Interactive comment on “Stratospheric isotopic water profiles from a single submillimeter limb scan by TELIS” by A. de Lange et al.

Received and published: 14 July 2009

1 Response

Fig. 1. The error propagation of the limited accuracy on the temperature on the retrieved HDO and H₂-18O profiles is depicted. The error is given in % relative to the true state vector and can thus directly b

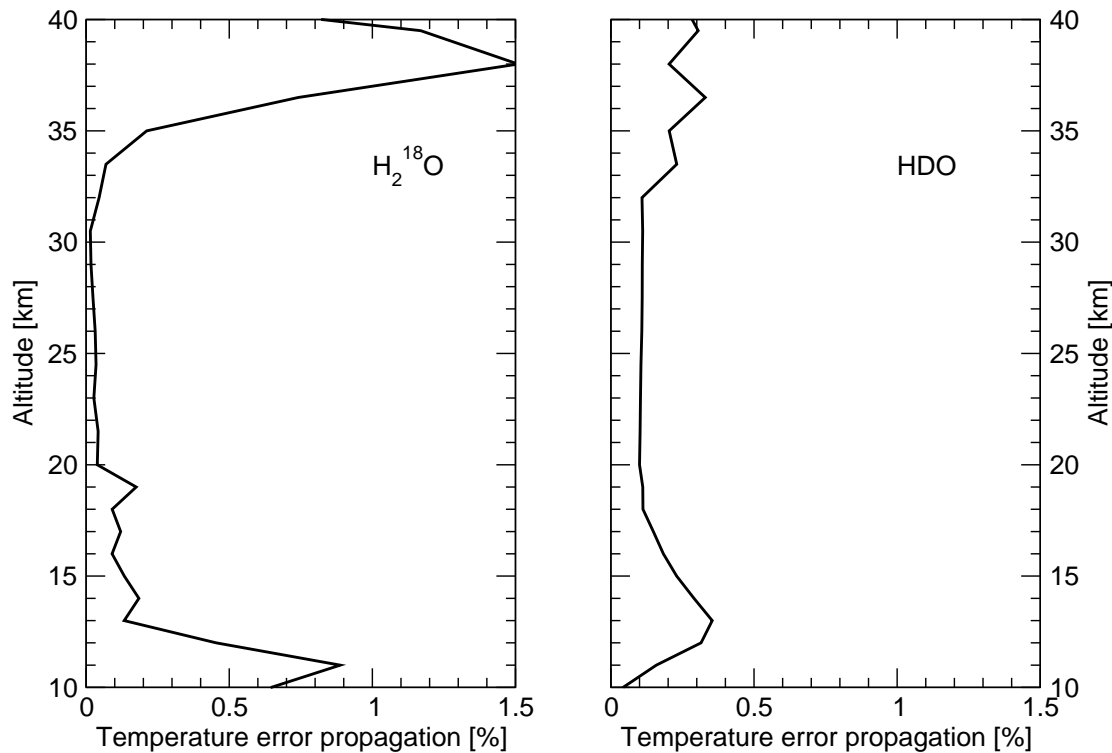
p869, line 11: Error propagation for these unmeasured quantities is not taken into account. It would seem at least reasonable to assume an uncertainty in the temperature profile and carry out an error propagation for the sensitivity study.

Author: I agree that this would make the paper stronger as it addresses another error source that can be anticipated upon. The proposed analysis has been performed and I propose to remove the line on ¹⁶O¹⁸O on p869 and add in stead the following as section

"The assumed temperature profile has only limited accuracy and may therefore have an impact on the retrieval error. The temperature profile will be taken from the analysis data by the ECMWF (European Centre for Medium-Range Weather Forecasts). The accuracies for March 2009 in Northern Scandinavia is on the order of 1 K up to the maximum validated pressure level of 10 mbar which corresponds to an altitude of ≈ 32 km (private communication, Fielding, 2009). A slight increase can be discerned above ≈ 27 km. The accuracies are in the following analysis set to 1 K for altitudes up to 27 km and then a gradual increase to 2 K at 46 km. To assess the error propagation of this uncertainty onto the retrieved rare water isotopologue profiles the following formula is employed:

$$\mathbf{S}_{\bar{x}} = \mathbf{D}\mathbf{K}_T\mathbf{S}_T\mathbf{K}_T^T\mathbf{D}^T, \quad (1)$$

with \mathbf{S}_T the ECMWF temperature covariance matrix, \mathbf{D} the contribution matrix, \mathbf{K}_T the Jacobian of the temperature, and $\mathbf{S}_{\bar{x}}$ the covariance matrix of the retrieved state vector (Rodgers, 2000). The result of this analysis is depicted in Fig. 1 (at the end of this document). As can be seen, the error is in the range of the tangent heights only $\approx 0.2\%$, which is less than the retrieval error (see Fig. 3) and is therefore of only minor consequence. Alternatively, the temperature profile may be determined from the measurements from the $^{16}\text{O}^{18}\text{O}$ line at 508.996 GHz."
